Service Bulletin

Bulletin No.: 23-NA-028

Subject: Front Lower Skid Plate Detached

6281445

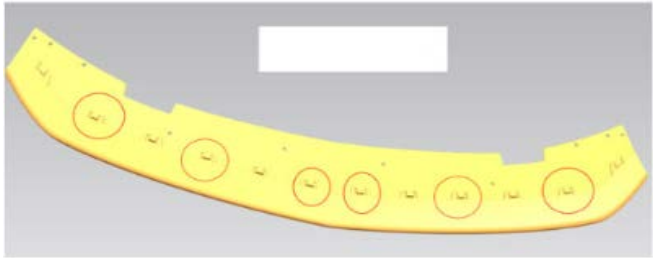
1. Remove the skid plate. Refer to *Front Bumper Fascia Skid Plate Replacement* in SI
2. With the Skid Plate removed, inspect the skid plate.
 - Do Not replace the Skid plate if it has not detached from vehicle or experienced any physical damage such as road rash or broken or deformed snap tabs. If no damage is noted, simply re-engage snap tabs on skid plate into lower fascia openings and secure with zip ties – as shown in steps below for zip tie location, orientation and quantity.

- If the Skid Plate has partially or completely fallen off the vehicle, and is visibly damaged replace with new skid plate and attach zip ties as shown in steps below. Example of damaged Skid Plates to be replaced are shown above.

Note: The two parts available are 84361212 Silver and 84226203 Black. There was a change to the part, but not the number, so if the part you receive has clips in the box, it is the new design and zip ties are not needed, but be sure to install the shoe clips in the end snap tab locations. If the new part does not have the clips in the box, you will need to install the zip ties.
